Project Name: Independence Plaza - Minor Sub. & Rezone-C2 to C1

FILE NO. 6-85 TITLE HEADING Independence Plaza-Minor Subdivision DUE DATE 3/12/85

RESPONSE TO REVIEW SHEET COMMENTS

INDEPENDENCE PLAZA SUBDIVISION
 GRAND JUNCTION, COLORADO
GRADING, DRAINAGE and UTILITY PLAN

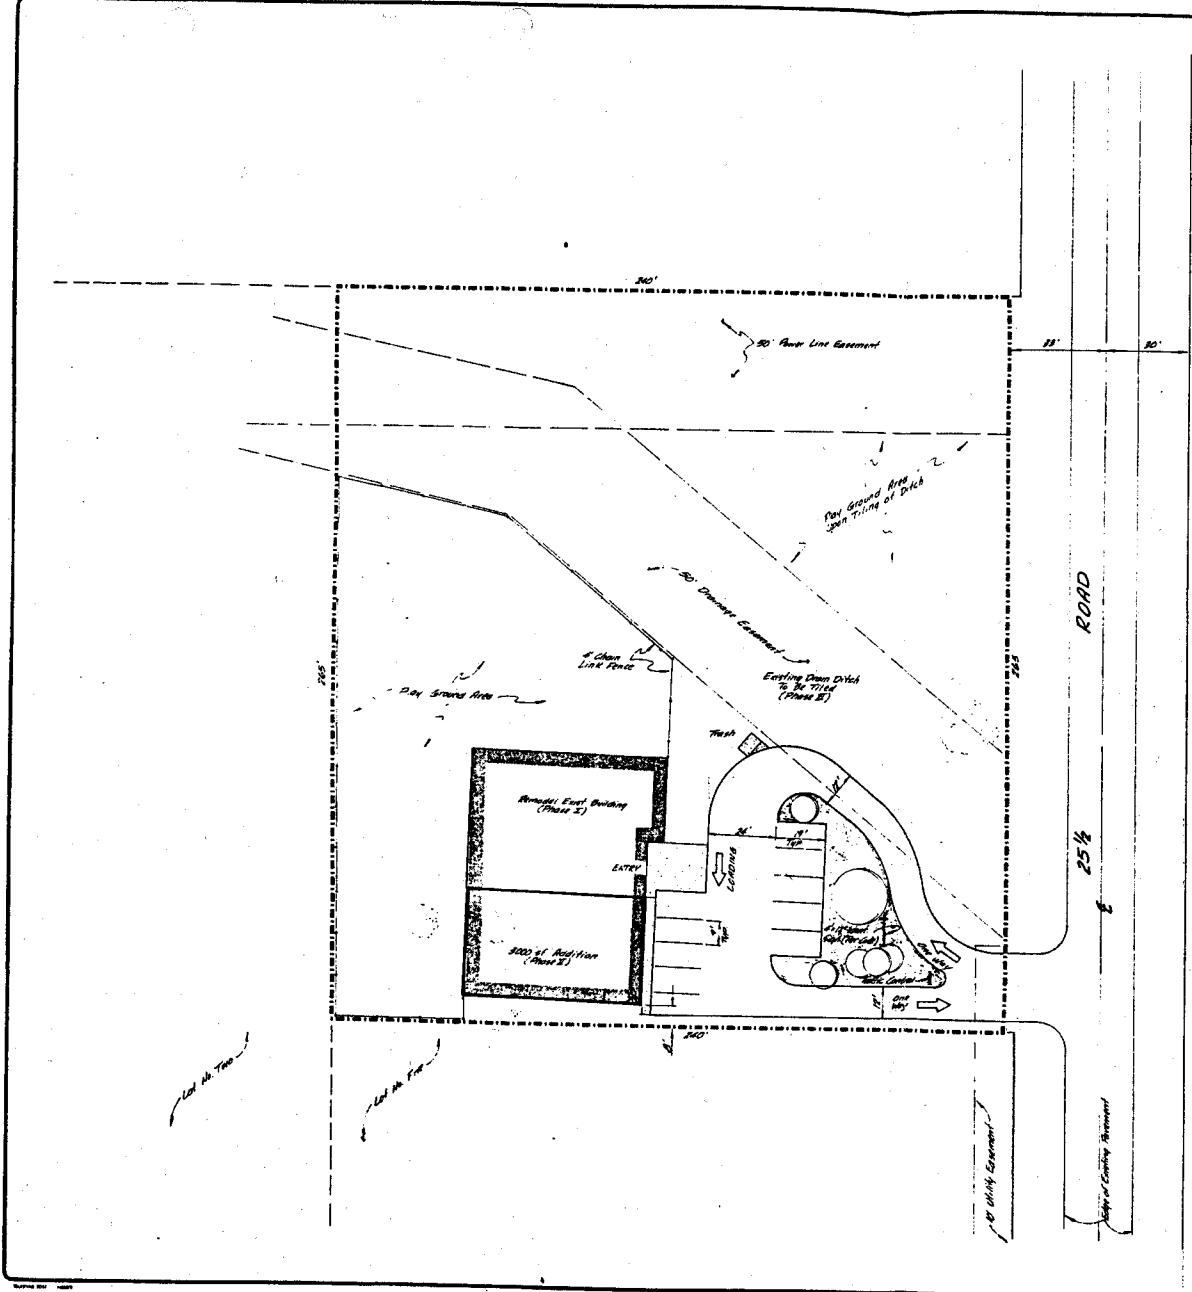
<u>DATE REC.</u>	<u>AGENCY</u>	<u>COMMENTS</u>
3/5/85	Mtn. Bell	Easements appear adequate.
3/5/85	County Planning	No comment.
3/11/85	Public Service Gas: Electric:	No objections. We request the east ten (10) feet of lots 2 and 3 be designated as utility easement. Also, we request the Grand Valley Rural Power easement be changed to utility easement.
3/12/85	City Engineer	Drainage study will be required for Lot 1 prior to Phase II addition to existing building. Drainage study for other four lots should be completed prior to development of these lots. It is our understanding that all streets within this subdivision will be private (no permanent right-of-way shown) and will be maintained by the developer. Escrow account should be set up in the amount required for improvements to 25 1/2 Road and Independent Avenue along subdivision frontage.
3/12/85	Public Works	<ol style="list-style-type: none">1. Because the driveway enters 25 1/2 Road at the bottom of the hill (lot 1), an analysis of the stopping site distance for vehicles south bound on 25 1/2 Road should be done.2. Trees south of the driveway on the west side of 25 1/2 Rd. should be cleared to improve site distance to south.3. What provisions have been made to allow drainage district access to maintain ditch?4. Will trash trucks be able to make turn when they pick up trash on lot 1?5. All design work to be reviewed by the City should be done by a licensed professional engineer in Colorado.6. The pavement section should be based on soil properties consistent with the area. The pavement section within City right-of-way should have a minimum of 3" of hot bituminous pavement supported by a minimum of 8" aggregate base course.

3/12/85	Fire Dept.	The Grand Junction Fire Department has no objections to this rezone. The Grand Junction Fire Department will require one fire hydrant to be placed at driveway entrance off 25 1/2 Rd. on existing 8" water main. Remodel of existing building and new addition must meet 1982 Uniform Fire Code and Building Code requirements for Child Day Care facilities. Additional fire protection may be required when subdivision is further developed.
3/12/85	Development Dept.	<ol style="list-style-type: none">1. Minor Subdivision: No dedicated internal access is shown on the plat for Lot 1. We would recommend the idea of sharing/joint use of accesses along 25 1/2 Rd. to help minimize curb cuts. As discussed, we will require open space fees to be paid with the recording of the plat. The petitioner may request the Council to consider deferring payment of the open space fees on the undeveloped lots

1. Again consider the idea of shared access along 25 1/2 Rd. to help minimize curb cuts and given the steep hill, maximize traffic safety.
2. Check for any sight distance problems at the entry.
3. All building construction will have to meet UBC and UFC requirements.
4. A separate sign and fence permit will be required.
5. Will the parking lot be paved? The existing site does not reflect the proposed site plan. What is the timing of the improvements and Phase II addition?
6. All other review agency comments must be satisfied.
7. If a C-1 zone is approved, all C-1 requirements of Sec. 4-2-13(C-1) will have to be met.
8. Any new exterior lighting proposed? If so, we recommend directional internal lighting to avoid adverse effects across the street with the residential units.

Response
Drainage study follows as requested for Lot 1 at this time.

See grading, drainage and utility plan for Independence Plaza Subdivision

Total area in Lot 1 = 1.5 AC.

Area in drainage basin B = 0.6 AC.
Q100 Drainage Basin B = 1.0 cfs

Developed storm water flows will discharge by sheet flows to Lot 2 and crosses Lot 2 to the discharge point of Drainage Basin "C".
